Planning & Development Division
Planning & Economic Development Department

File Number	PL 22-088	Contact	Kyle Deming, kdeming@duluthmn.gov	
Type	Variance – building height	Planning Commission Date		June 14, 2022
Deadline for Action	Application Date	May 17, 2022	60 Days	July 16, 2022
	Date Extension Letter Mailed	May 23, 2022	120 Days	September 14, 2022
Location of Subject		3731, 3819, 3829, 3867 London Rd.		
Applicant	Stocke Construction	Contact	Ted Stocke	
Agent		Contact		
Legal Description		Lots 13, 14, 23-26, Block 1, London East Division (010-3075-00130, -00140, -00230, -00240, -00250, -00260) and Lots 8 & 9, Block 31, Rearrangement of East Duluth and First Addition to East Duluth (010-1370-05060)		
Site Visit Date	June 1, 2022	Sign Notice Date		June 1, 2022
Neighbor Letter Date	May 26, 2022	Number of Letters Sent		19

A variance to allow a one-family dwelling to be constructed at each address listed above that is 40 feet tall instead of the 30 feet maximum building height per UDC Section 50-14.5. The project is within the London East twinhomes development.

PL22-088
Building Height Variance
3731, 3819, 3829, &
3867 London Rd.
Stocke Construction

REAR ELEVATION
SCALE: 1/4" = 1'-0"

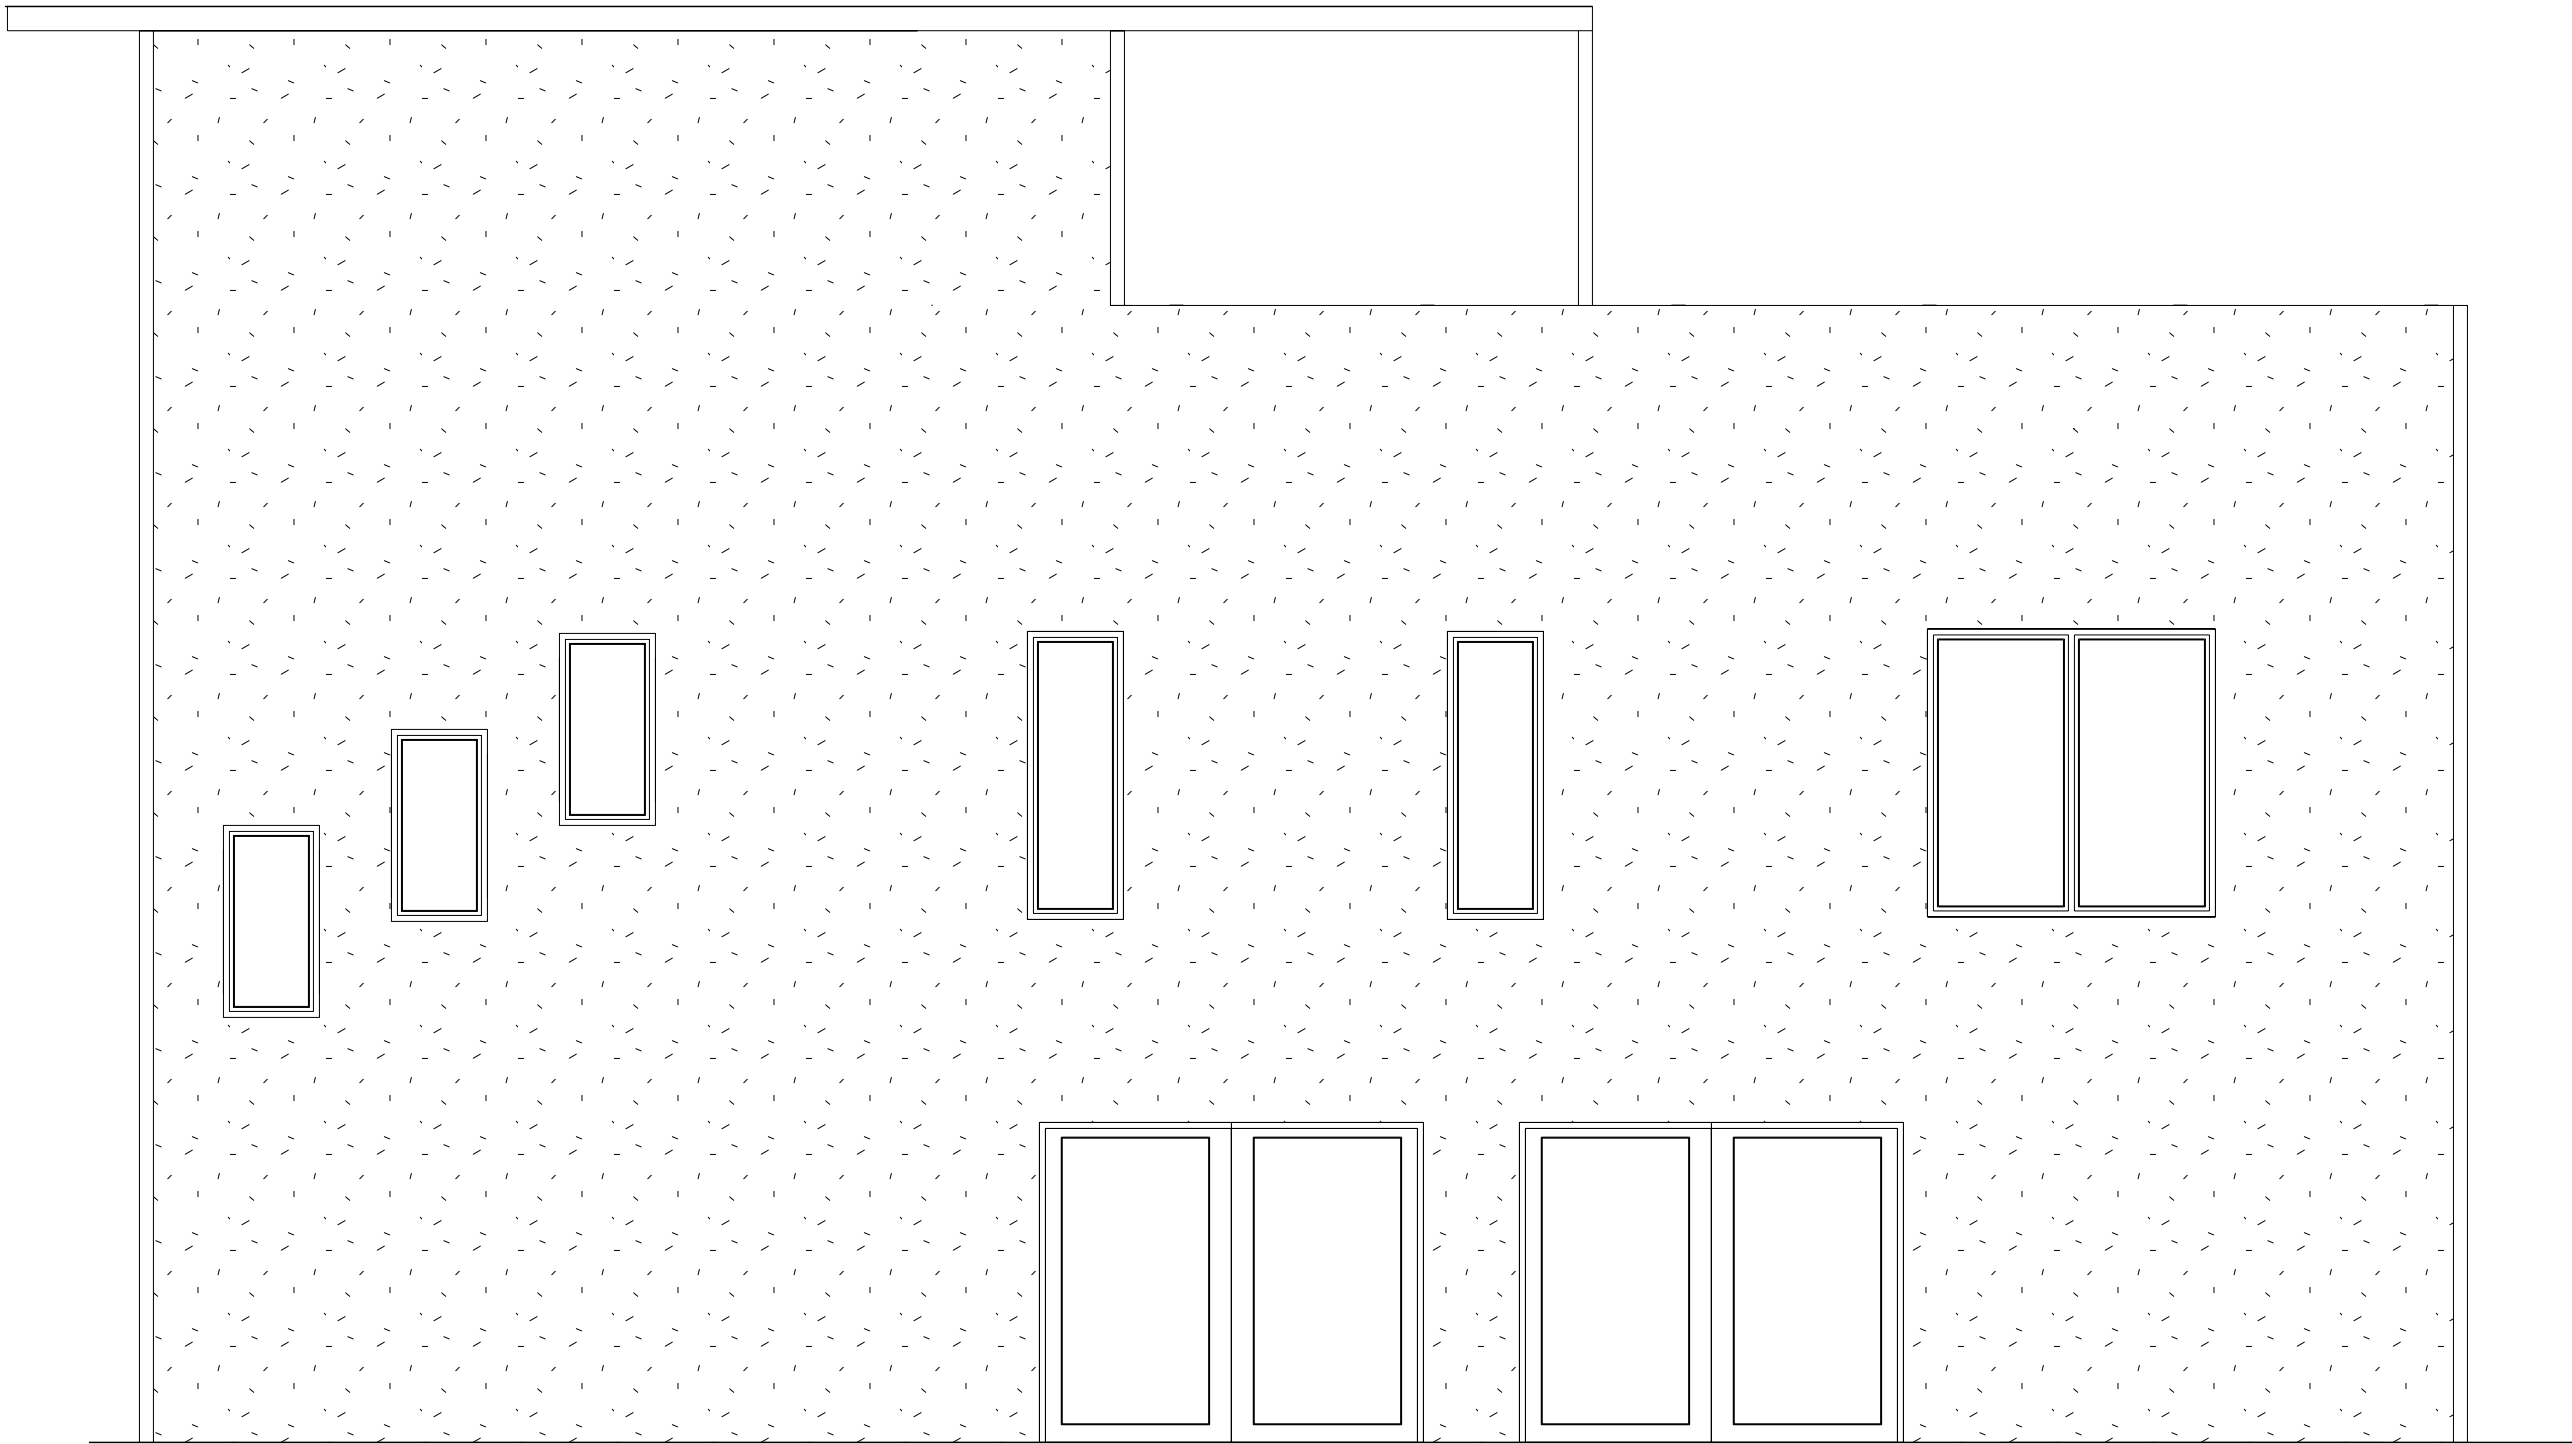
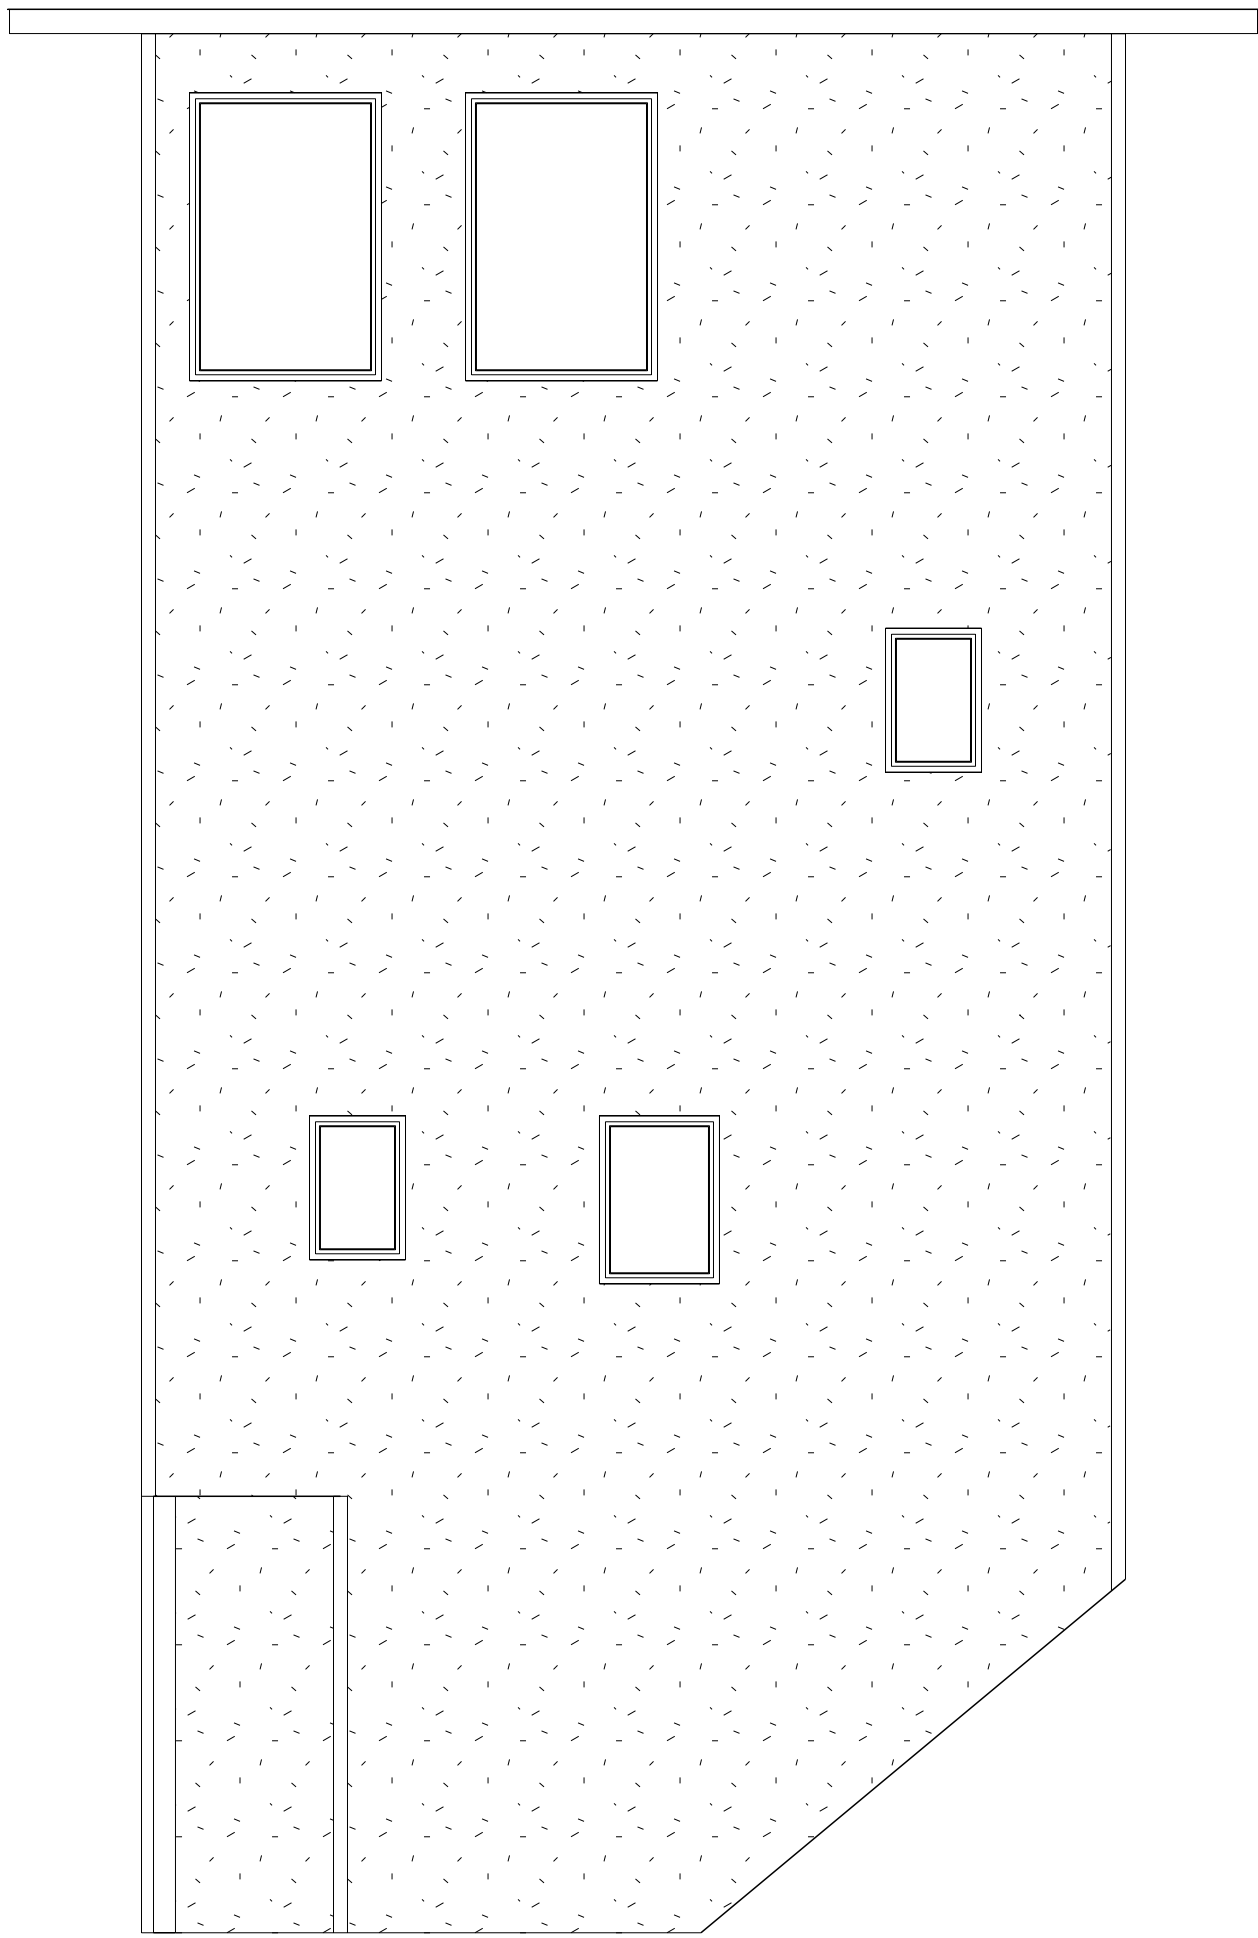
1. The site is part of the 3.14 ac. London East twinhome development.
2. Applicant is proposing to construct 4 one-family dwellings in the eastern part of the development that would be 40 feet tall instead of the 30 feet allowed in the R-1 district. According to the plans, the portion of the building exceeding the maximum height consists of a 20-foot-wide by 22-foot-deep enclosed space, a 10-foot-wide by 22-foot-deep arbor, and an 18-foot-wide by 22-foot-deep open patio with standard height fall protection walls or railings

7. Granting the variance will not alter the essential character of the area because the proposed 48-foot-wide, 40-foot-tall structures will have a similar bulk to the twin homes on the adjacent lots within the development. Additionally, across London Rd. are three large apartment buildings, one 170 feet long by 3 stories, one 270 feet long by 3 stories, and one 240 feet long by 6 stories tall. The recently completed Zvago condominium building is 4 stories tall and the Ecumen Lakeshore complex includes 3-story buildings of a similar height when including the steeply pitched roofs.

11. Granting the variance is not expected to unreasonably diminish established property values in the area because the building height will not impact the view from the northwest compared to the pre-development site condition that consisted of dense tree cover in excess of the proposed building heights. The building locations far back from London Road are not expected to impact the values of property on the lower side of London Road due to the distance and mature vegetation on the properties providing screening.

- 1) The project be limited to, constructed, and maintained based on the plans submitted with the application that shows the portion of the building exceeding the maximum height consisting of a 20-foot-wide by 22-foot-deep enclosed space, a 10-foot-wide by 22-foot-deep arbor, and an 18-foot-wide by 22-foot-deep open patio with standard height fall protection walls or railings.
- 2) Any alterations to the approved plans that do not alter major elements of the plan may be approved by the Land Use Supervisor without further Planning Commission; however, no such administration approval shall constitute a variance from the provisions of Chapter 50.
